From: Medak, Christine <christine_medak@fws.gov>
Sent: Wednesday, September 14, 2016 1:17 PM
To: GYU@dpw.lacounty.gov
Cc: Rogers, Bonnie L SPL; Mari (Schroeder) Quillman; Vargas, Jessica M SPL; Chirdon, Matthew@Wildlife; Jonathan Snyder
Subject: Review of On-Site Mitigation Hydrology Justification
Attachments: Appendix_D_hydrology-report_small.pdf

Devil's Gate Sediment Removal and Management Plan
On-Site Mitigation Hydrology Justification

Design Storm - 2Yr 4th Day <Current Op Plan>

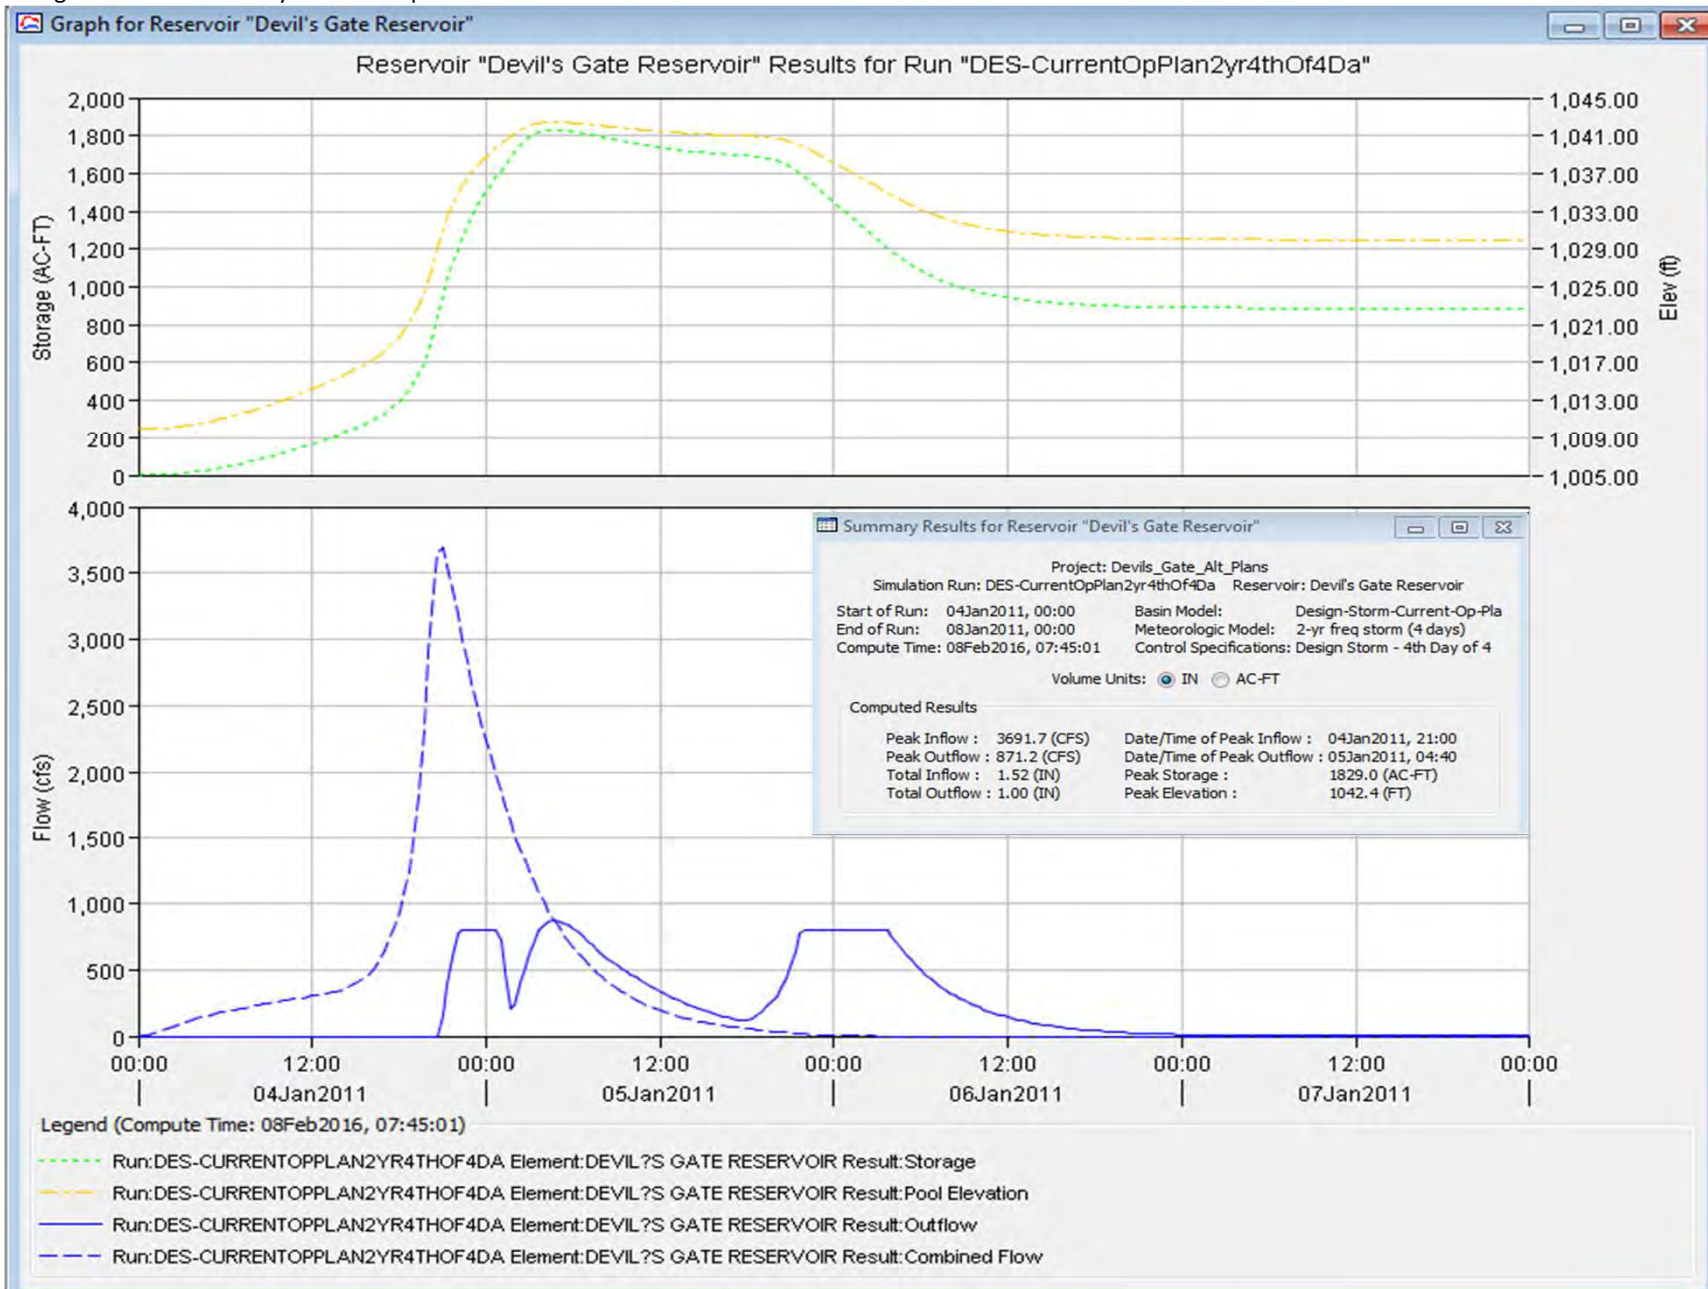
8) Attachments 8 and 9 of the Justification compare a modeled 2-year event with an actual event in January 2008. In the modeled event, the peak inflow is 3691.7 cfs and in the actual event, the peak inflow is 5720.4 cfs. Clarify if the actual event is a 2 year or 5 year event. Both events anticipate flows reaching about 1040' elevation. Clarify if this elevation is reached as a result of water backing up behind the dam or if surface flows sufficient to cause scour and deposition of sediment will occur at this elevation. If no scouring flows are anticipated during a 5720.4 cfs event, what level of flows will be required to cause scour and deposition within the remaining riparian habitat, outside the permanent impact footprint?

LOS ANGELES COUNTY DEPARTMENT OF PUBLIC WORKS
DEVIL'S GATE
DAM & RESERVOIR
JANUARY 19, 2009

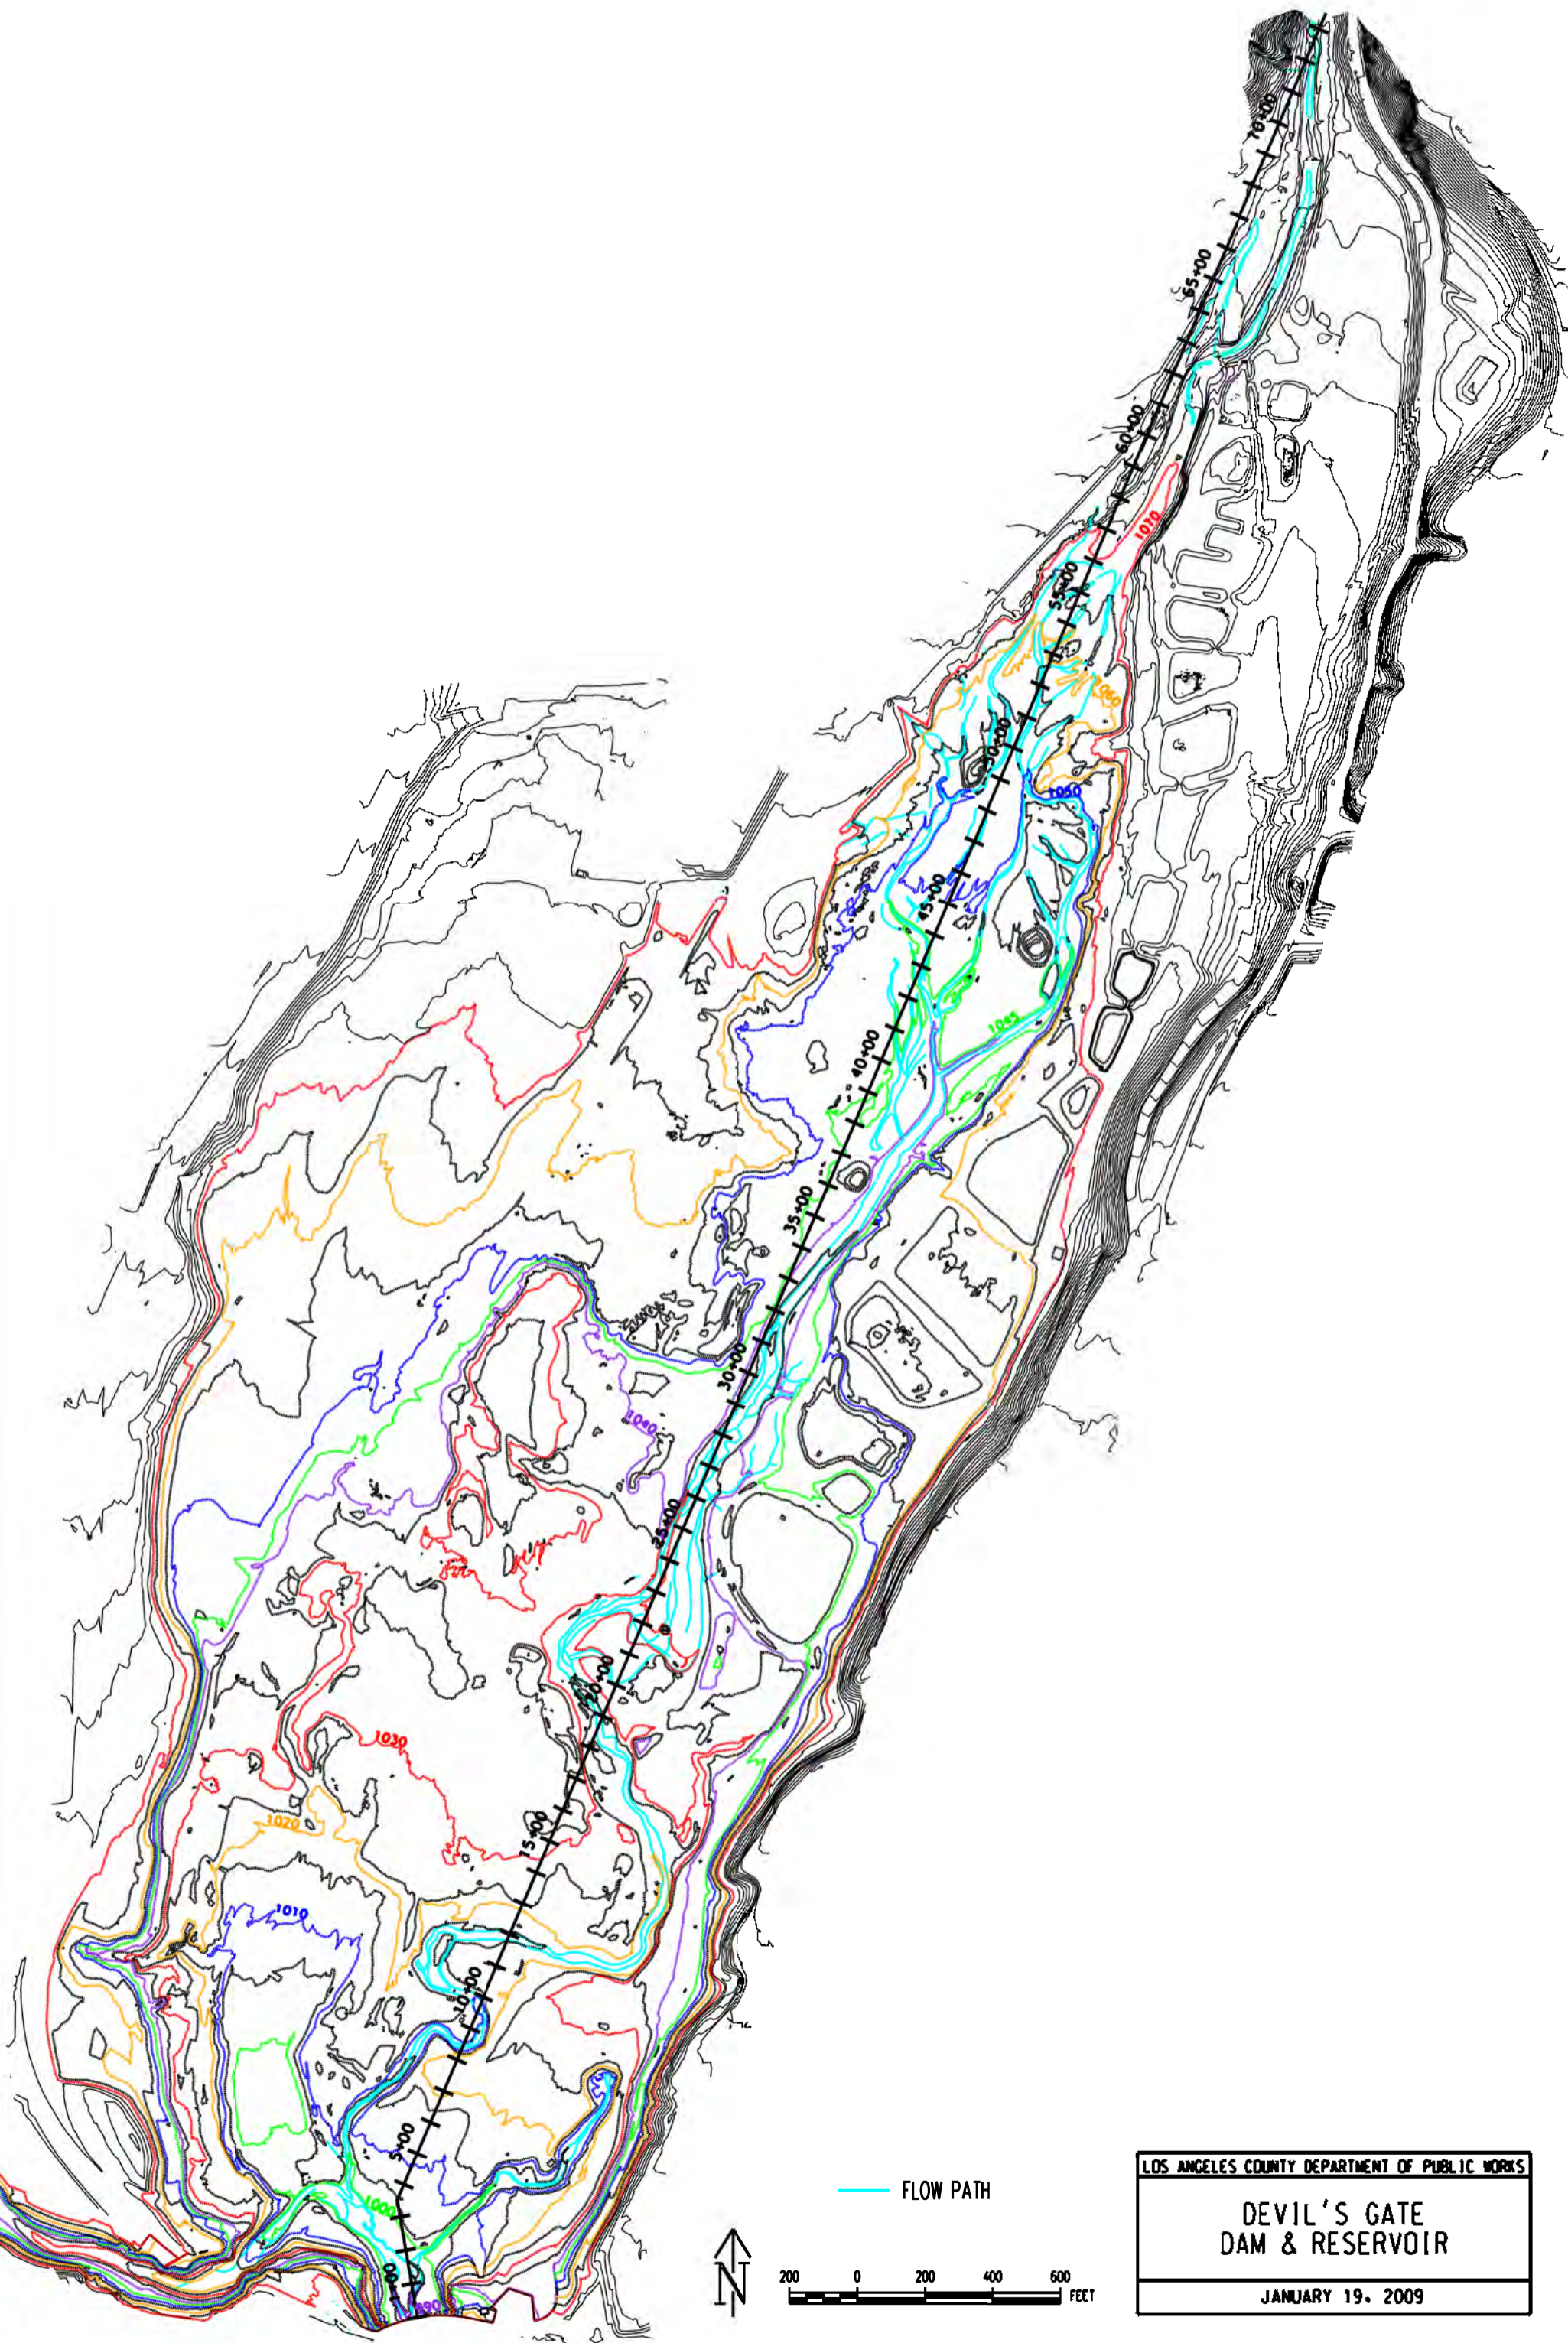
9) Attachments 10 and 11 compare the 2009 topography with the proposed project. How does the proposed project compare with the current topography? The approved project (attachment 11) appears to include changes in topography west of the proposed project footprint. Was the modelling based on this topography? Is the additional grading (beyond the proposed project footprint) required? Are the grading limits for the proposed project based on current topography?

DEVIL'S GATE RESERVOIR PROFILE

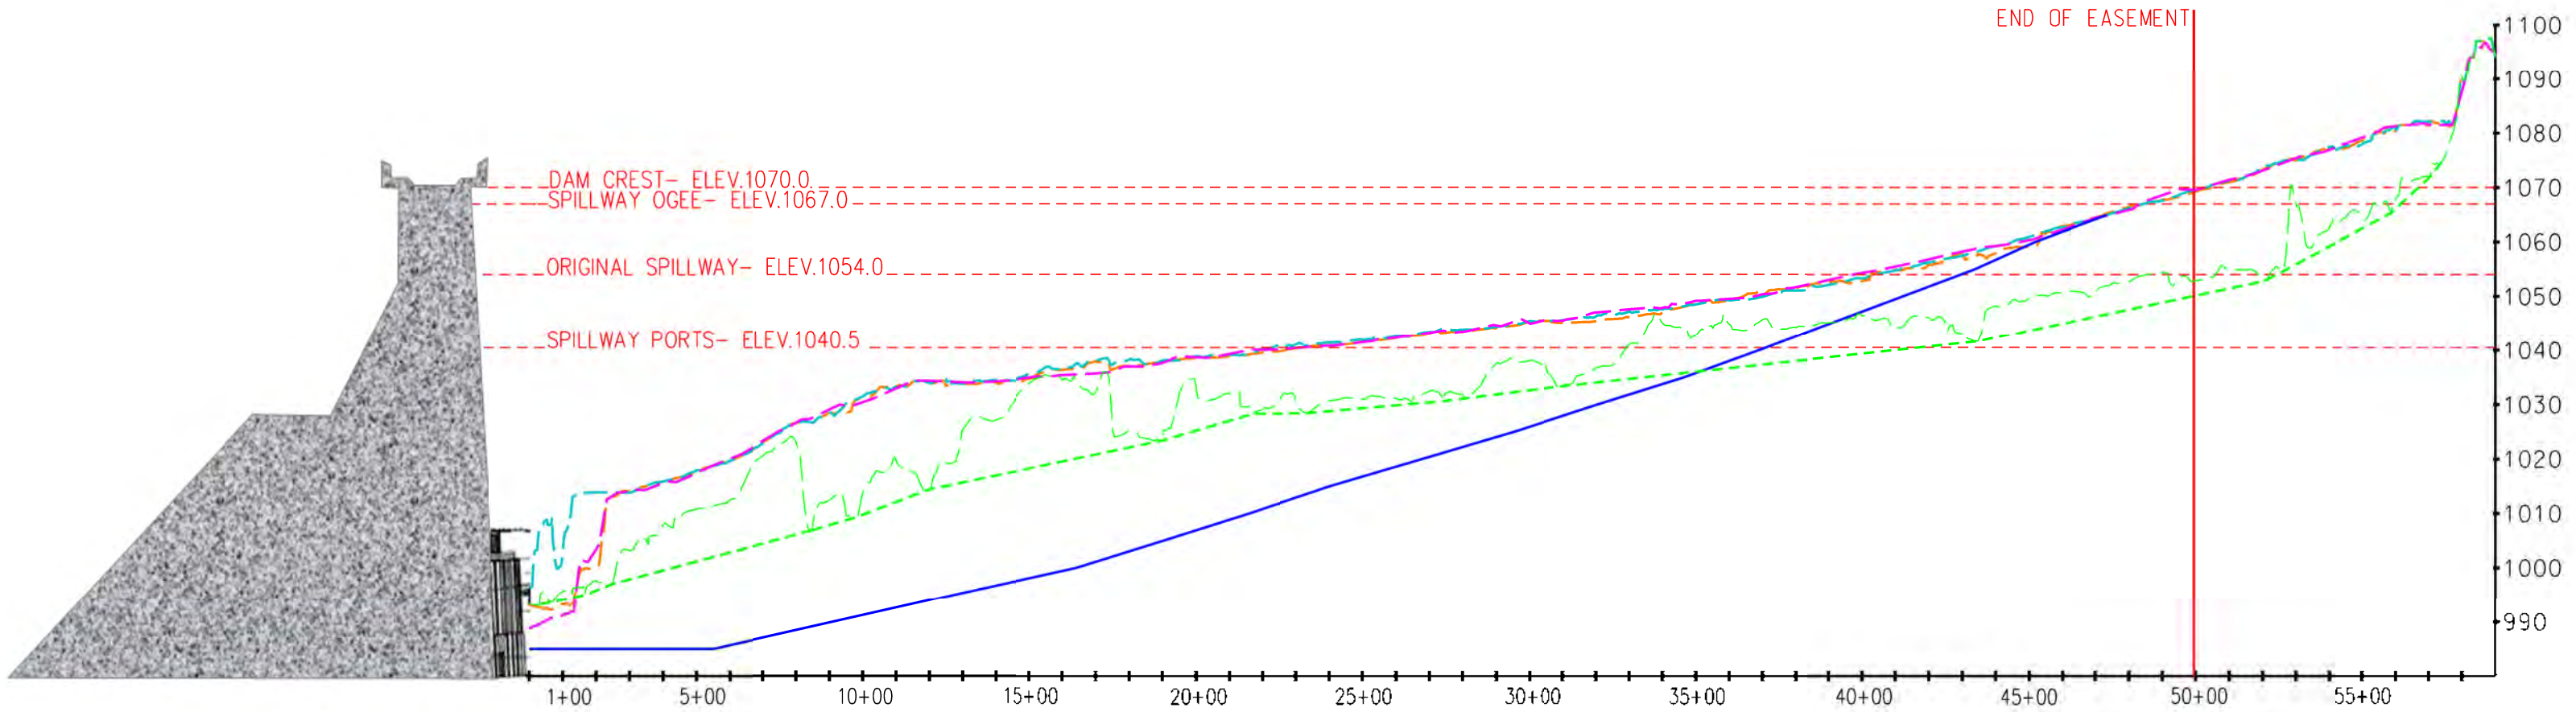
10) Attachment 12 compares the slope of the low flow channel over time with the proposed project. While the streambed elevation increased between 2009 and 2014, the slope appears to remain about the same. The proposed project will increase the slope substantially relative to the 2009/2014 slope. Will this cause a headcut upstream? How far upstream do you anticipate the headcut to extend as a result of increasing the gradient of the streambed? Does the proposed annual maintenance account for erosion of the bed and banks associated with the headcut?

LOS ANGELES COUNTY DEPARTMENT OF PUBLIC WORKS
**DEVIL'S GATE
DAM & RESERVOIR**
JANUARY 19, 2009

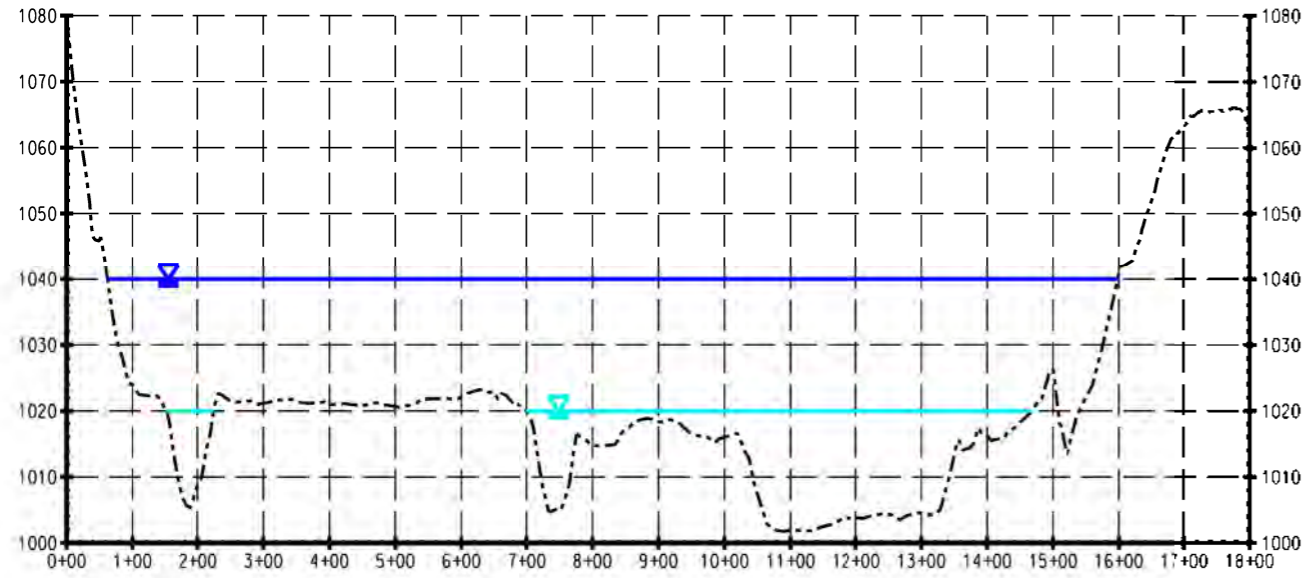
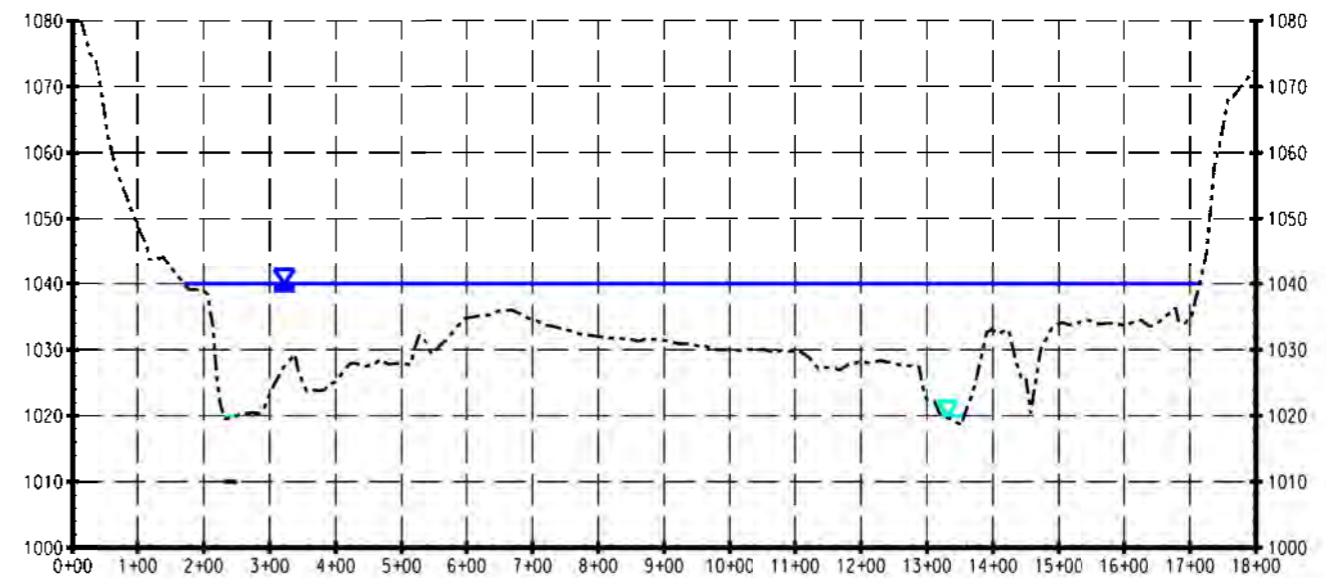
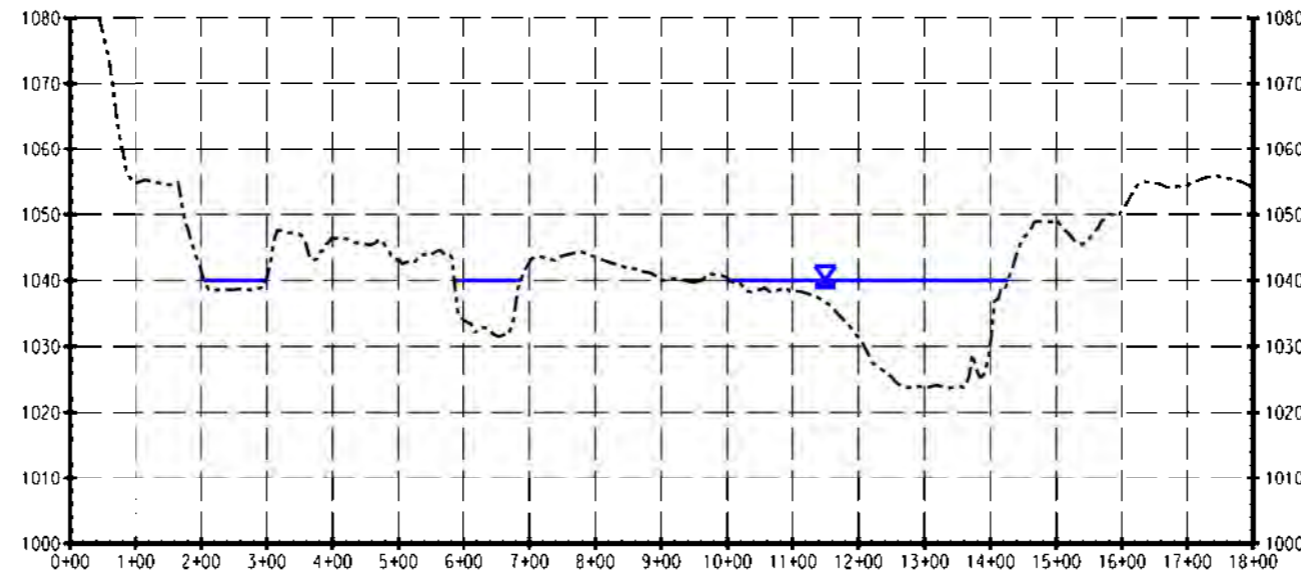
11) Attachments 15 and 17 compare cross sectional profiles in 2009 and with the proposed project. While the 1040' elevation contours appear similar, there is substantially more capacity below 1020' elevation with the proposed project. We are concerned the increase in capacity and confinement of flows within the permanent impact footprint will decrease the frequency of surface flows reaching remaining habitat. Riparian vegetation suitable for vireo breeding, feeding and sheltering consists of a complex structure of understory, midstory and canopy vegetation that is maintained by natural processes. Restoration conducted in areas that will be isolated from natural processes will need to be managed in a way that not only provides adequate soil moisture but also maintains the structural diversity necessary to support the species. The management actions necessary to maintain habitat for the vireo over the long term should be included as part of the proposed habitat restoration and management plan.
